County of Fairfax, Virginia

STAFF REPORT ADDENDUM

PCA 82-P-069-15, CDPA 82-P-069-3-1,
FDPA 82-P-069-01-14 and FDPA 82-P-069-10-4

PROPOSAL: Request to amend the proffers, the Conceptual Development Plan, and the Final Development Plan for a portion of Fair Lakes to permit the construction of 267,000 gross square feet of office development and to provide specific proffers related to the proposed office use in Land Bay V-A.

TITLE: **FAIR LAKES V-A
 CONCEPTUAL / FINAL
 DEVELOPMENT PLAN / AMENDMENT**
 CDPA 82-P-089-10-1
 CDPA 82-P-089-10-4
 CDPA 82-P-089-10-4
 PRIMARY ENTRY CONDITION
 LANDSCAPE DETAIL 8
 PROJECT NO. M-118577

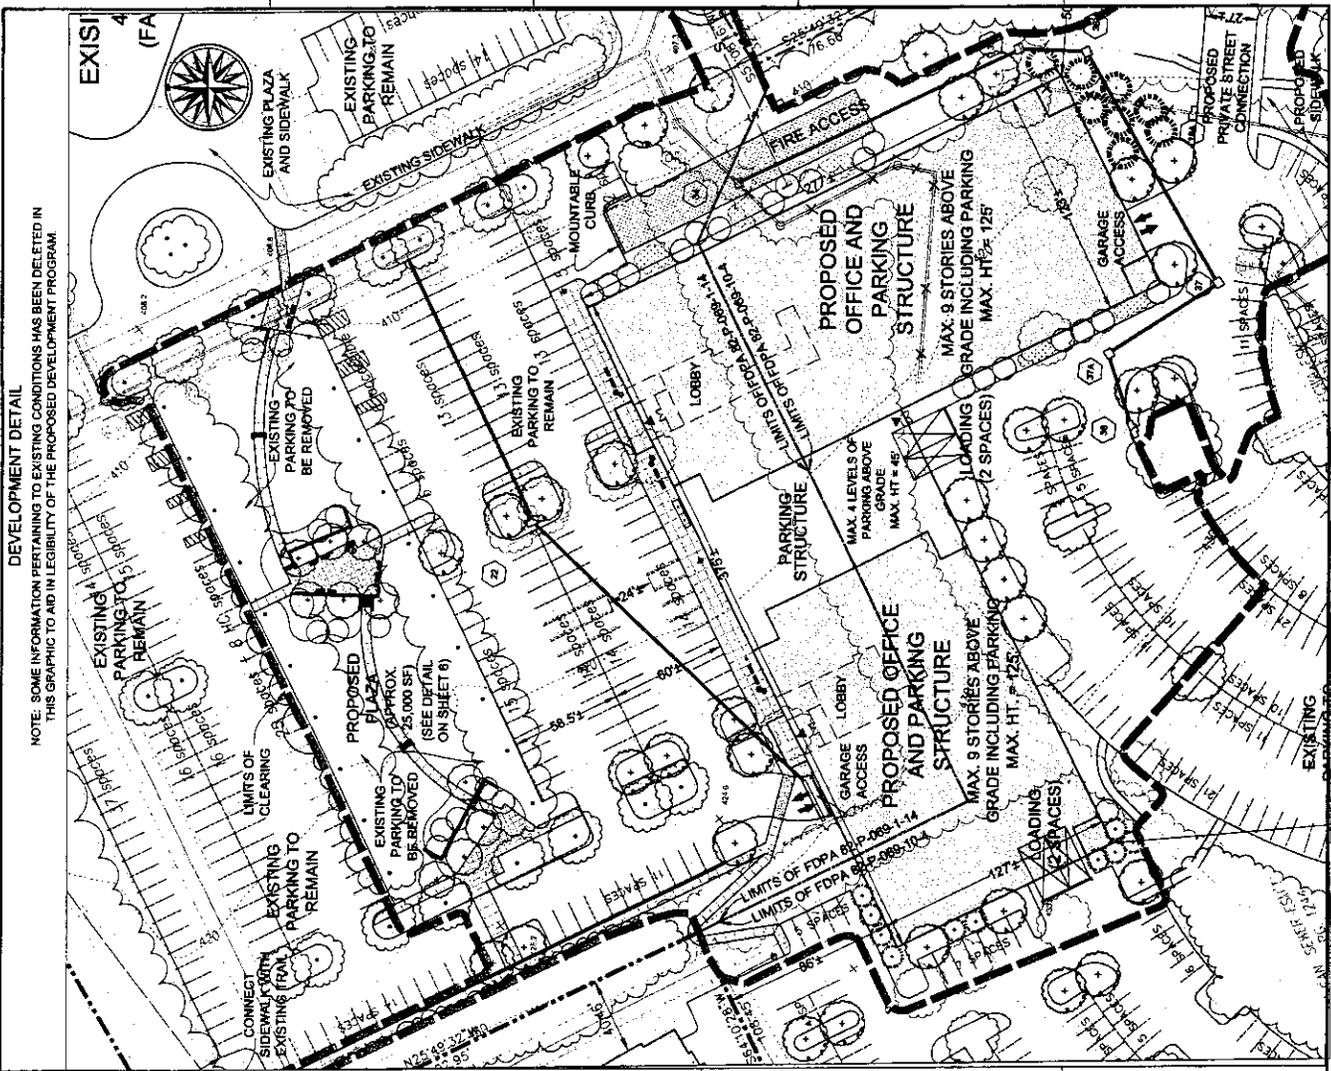
Modification of PFM standard 12-0702.1B2 to permit the reduction of the minimum planting requirement from a minimum width of 8 feet to a minimum width of 6 feet as shown on the CDPA/FDPA.

The PFM requires that, at a minimum, street trees be planted in an eight (8) foot wide planting strip. The applicant is seeking a modification of this requirement in select locations of the site, primarily along internal streets, based on the premise that an at-grade eight (8) foot wide planting strip is too wide to facilitate a pedestrian-oriented streetscape. For that reason, in select locations as shown on the CDPA/FDPA, the applicant proposes to provide eight (8) foot wide planting beds for street trees, but to cantilever the sidewalk two (2) feet over such planting beds. The result is that an eight (8) foot wide planting area would be provided for the trees, but only six (6) feet of such area would be visible from grade level. In order to ensure the survivability of the trees, the applicant proposes to install structural soil and/or structural cells within these eight (8) foot wide planting areas. The applicant's proposed landscaping plan has been reviewed by the UFM and their recommendations have been incorporated into the CDPA/FDPA proffers. Therefore, staff supports the requested modification.

9. **Landscaping.** Landscaping shall be generally consistent with the quality, quantity and the locations shown, respectively, on the "Landscape Detail" included as Sheet 4 and 6 of the CDPA/FDPA. At the time of planting, the minimum caliper for trees shall be as follows: large deciduous trees shall be at least three (3) inch caliper, and large evergreen trees shall be at least eight (8) feet in height. Actual types and species of vegetation shall be determined pursuant to more detailed landscape plans submitted at the time of site plan, for review and approval by UFM. Preference shall be given by the Applicant to utilizing native species to the extent feasible. This shall not be construed, however, to preclude the use of non-native species. Such landscape plans shall provide tree coverage and species diversity consistent with the PFM criteria, as determined by UFM.

Trees planted in areas which are less than eight (8) feet in width and/or do not meet the minimum planting area required (before any approved modification) by the Public Facilities Manual ("PFM") may be counted towards satisfying the minimum tree cover requirement provided that structural soils or structural cells are incorporated as specified herein. The Applicant shall provide structural soils or structural cells with a minimum depth of 24 inches. The minimum width of areas of structural soils or structural cells shall be eight (8) feet, which may extend beneath any paved surface, so long as a minimum of 130 square feet is provided for Category IV trees and 90 square feet is provided for Category III trees, as such trees are identified in the PFM. Such planting areas shall be interconnected to the extent feasible, as determined by UFM. Geotextile fabric shall be provided between the structural soil or structural cells and the surrounding media as required by the specific application. The residual opening in the planting area may be mulched, landscaped or covered by a tree grate. At the time of site plan submission, the Applicant shall provide written documentation, including information about the composition of the structural soil or specifications regarding the structural cells to UFM indicating that a qualified and appropriately licensed "company" provided the structural soil or structural cells. The Applicant shall provide 72-hour notice to UFM prior to installation of the soil to allow verification of the composition of the structural soil or structural cells and verification that the structural soil or structural cell is the correct mix and is installed correctly. The Applicant shall provide written confirmation from a certified arborist and/or landscape architect demonstrating and verifying installation of structural soil or structural cells.

Staff recommends approval of a modification of PFM Standard 12-0702.1B2 to permit the reduction of the minimum planting width requirement from eight feet to six feet as shown on the CDPA/FDPA and described in the proffers.

THE FAIR LAKES V-A
 CONCEPTUAL / FINAL
 DEVELOPMENT PLAN AMENDMENT
 CDPA 82-P-089-08-01
 FDPA 82-P-089-10-4
 AMENDED DESIGN
 ALTERNATE ENTRY CONDITION
 LANDSCAPE DETAILS
 PROJECT NO. M-10627

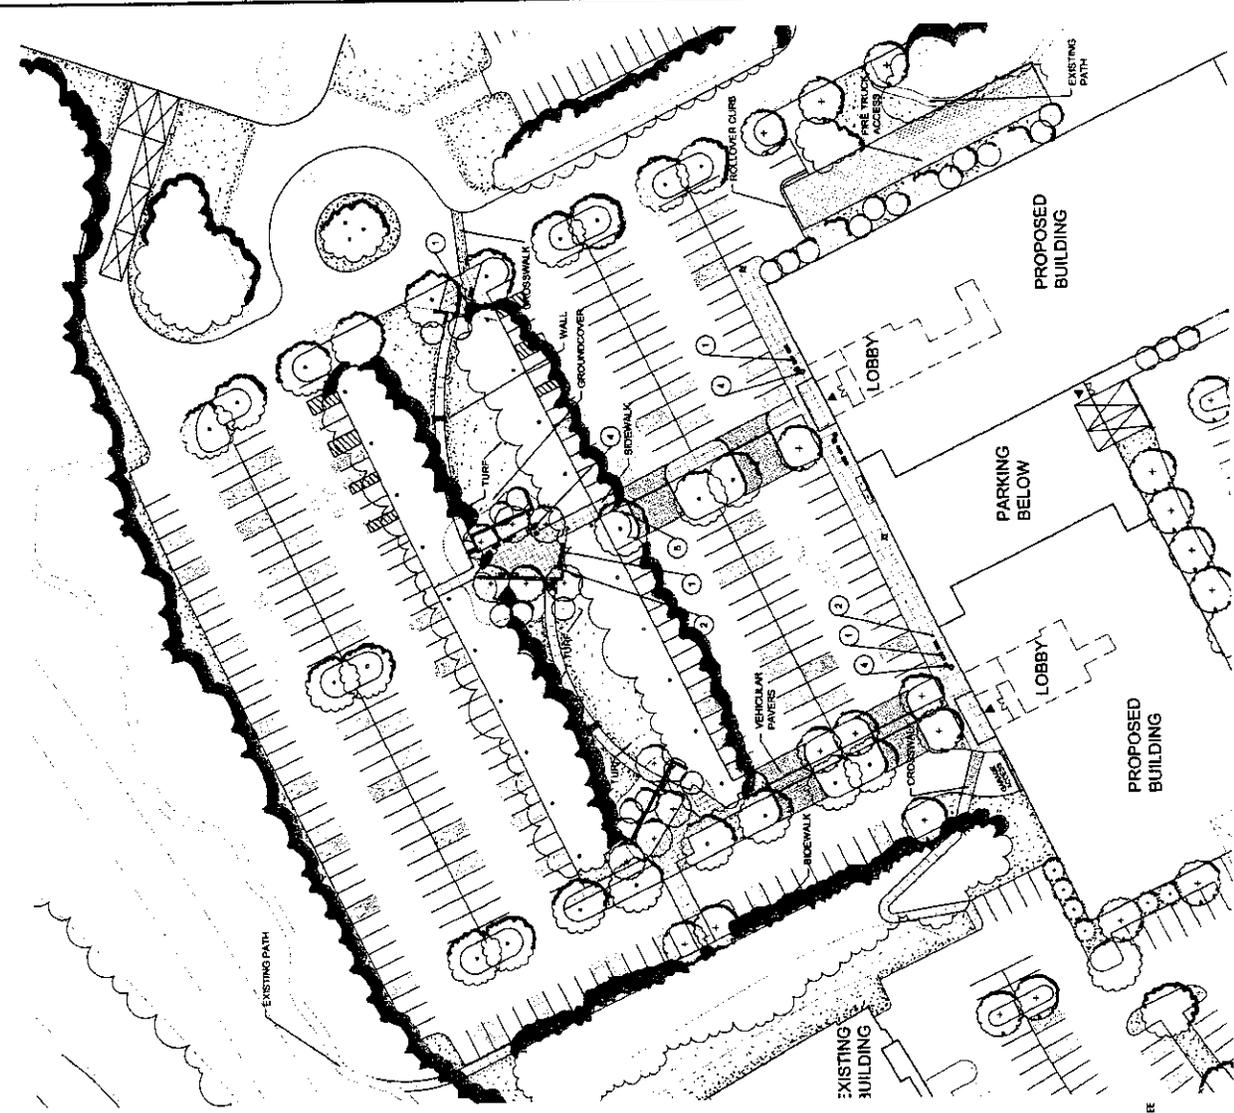
11. **Plaza Development.** Prior to the issuance of the initial Non-RUP for the office building, the Applicant shall improve the plaza area as detailed on Sheet 4 and Sheet 6 of the CDPA/FDPA. The Applicant shall construct either of the plaza designs depicted on Sheet 4 or Sheet 6 depending upon the lobby location pursuant to Paragraph 13 below. A public access easement shall be provided for the public plaza constructed by the Applicant.
